**ELECTRICITY INDUSTRY PARTICIPATION CODE
DISTRIBUTED UNMETERED LOAD AUDIT REPORT**

**WAKA KOTAHI WAIKATO
AND
GENESIS ENERGY
NZBN: 9429037706609**

Prepared by: Steve Woods

Date audit report completed: 3 January 2024

Example 3

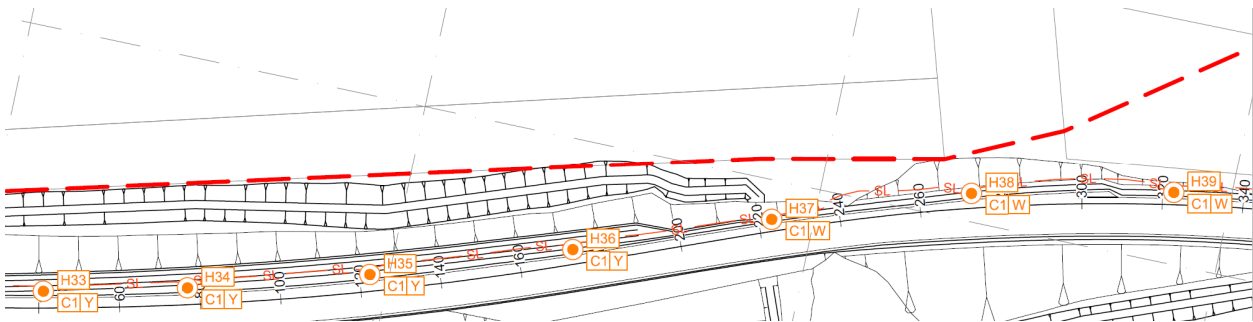
Pole No	Database wattage	Field wattage	Evidence
H33 to H39	ITALO 2 STW 4.5-8M 152W	AEC Italo 2 SV 4.5 5M 75W	<p>The first image below is from an “as built” plan supplied by NZTA, dated 03/03/2020. The top “box” shows the pole numbers of H33 to H39. Below there is a box with “C1”. C1 corresponds to the next image which is from the legend in the “as built” plan, and shows the wattage as 75 not 152.</p> <p>The field audit identified that this was a 5 module LED. In the description “5M” means 5 module. The database had it recorded as an 8 module (8M), and whilst the number of modules cannot necessarily determine wattage, it can alert to database errors. In this case NZTA confirmed the lamp type of “AEC Italo 2 SV 4.5 5M 75W”, which was further confirmed by the “as built” plan. The third and fourth images are of 5 module and 8 module lights.</p>

The field audit identified this as a 5 module LED not an 8 module LED.

C1 SUPPLY AND INSTALL A GROUND PLANTED OCTAGONAL GALVANISED STEEL COLUMN WITH A 2M OUTREACH ARM (REFER TO SPECIFIC NOTES 'G' AND 'H' ON DRAWING DG-R-4301) COMPLETE WITH AN AEC ITALO 2 SV 4.5 5M 75W LED LUMINAIRE (8090 LUMENS). THE LUMINAIRE SHALL BE MOUNTED AT A HEIGHT OF 10M AND BE TILTED AT AN ANGLE OF 0° TO THE HORIZONTAL.
